PRODUCT CHANGE NOTIFICATION (PCN)

A-MCSP-80050 MODULAR CABLE

CHANGE NOTIFICATION: PCN 20220425_A-MCSP-80050

DESCRIPTION OF CHANGES: CHANGE OF DATA SHEET
CHANGE OF DATA SHEET
New Draw.-No. ASS_7425_CArev07

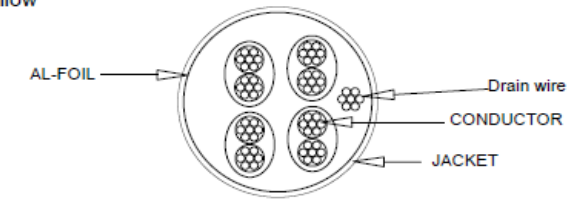
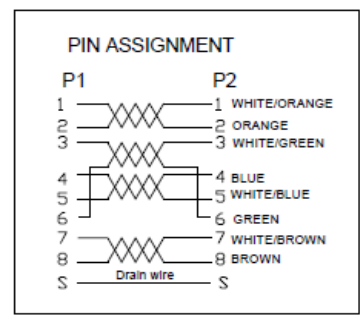
A-MCSP-80050	OLD VERSION	A-MCSP-80050	NEW VERSION																																																	
<p>Appearance</p>		<p>Appearance</p>																																																		
<p>BOM</p> <table border="1"> <thead> <tr> <th>NO</th> <th>PART NO</th> <th>DESCRIPTION</th> <th>QTY</th> <th>UNIT</th> </tr> </thead> <tbody> <tr> <td>3</td> <td>mold</td> <td>PVC,50P</td> <td>9.0</td> <td>G</td> </tr> <tr> <td>2</td> <td>plug</td> <td>8P8C plating gold 3U* with metal shield</td> <td>2</td> <td>PCS</td> </tr> <tr> <td>⑤ 1</td> <td>cable</td> <td>FTP (26AWG*1P)*4+D+A+PVC, OD:5.2±0.2mm CAT5E</td> <td>2.0</td> <td>M</td> </tr> </tbody> </table>		NO	PART NO	DESCRIPTION	QTY	UNIT	3	mold	PVC,50P	9.0	G	2	plug	8P8C plating gold 3U* with metal shield	2	PCS	⑤ 1	cable	FTP (26AWG*1P)*4+D+A+PVC, OD:5.2±0.2mm CAT5E	2.0	M	<p>BOM</p> <table border="1"> <thead> <tr> <th>NO</th> <th>PART NO</th> <th>DESCRIPTION</th> <th>QTY</th> <th>UNIT</th> </tr> </thead> <tbody> <tr> <td>⑦</td> <td>⚠</td> <td>AL-Foil</td> <td>Double-sided conductive aluminum foil</td> <td>2</td> <td>PCS</td> </tr> <tr> <td>⑦</td> <td>⚠</td> <td>mold</td> <td>PVC,65P</td> <td>AR</td> <td>G</td> </tr> <tr> <td></td> <td>⚠</td> <td>plug</td> <td>8P8C plating gold 3U* with metal shield</td> <td>2</td> <td>PCS</td> </tr> <tr> <td>⑦⑤</td> <td>⚠</td> <td>cable</td> <td>CAT5E F/UTP (26AWG*1P)*4+D+A+PVC, OD:5.2±0.2mm</td> <td>AR</td> <td>M</td> </tr> </tbody> </table>		NO	PART NO	DESCRIPTION	QTY	UNIT	⑦	⚠	AL-Foil	Double-sided conductive aluminum foil	2	PCS	⑦	⚠	mold	PVC,65P	AR	G		⚠	plug	8P8C plating gold 3U* with metal shield	2	PCS	⑦⑤	⚠	cable	CAT5E F/UTP (26AWG*1P)*4+D+A+PVC, OD:5.2±0.2mm	AR	M

NO	PART NO	DESCRIPTION	QTY	UNIT																																																
3	mold	PVC,50P	9.0	G																																																
2	plug	8P8C plating gold 3U* with metal shield	2	PCS																																																
⑤ 1	cable	FTP (26AWG*1P)*4+D+A+PVC, OD:5.2±0.2mm CAT5E	2.0	M																																																
NO	PART NO	DESCRIPTION	QTY	UNIT																																																
⑦	⚠	AL-Foil	Double-sided conductive aluminum foil	2	PCS																																															
⑦	⚠	mold	PVC,65P	AR	G																																															
	⚠	plug	8P8C plating gold 3U* with metal shield	2	PCS																																															
⑦⑤	⚠	cable	CAT5E F/UTP (26AWG*1P)*4+D+A+PVC, OD:5.2±0.2mm	AR	M																																															
<p>FOR DETAIL, PLEASE TAKE ATTACHED NEW DRAWING: FOR REFERENCE</p>

NO	PART NO	DESCRIPTION	QTY	UNIT
⑦	△	AL-Foil Double-sided conductive aluminum foil	2	PCS
⑦	△	mold PVC,65P	AR	G
⑦	△	plug 8P8C plating gold 3U* with metal shield	2	PCS
⑦⑤	△	cable CAT5E F/UTP (26AWG*1P)*4+D+A+PVC, OD:5.2±0.2mm	AR	M
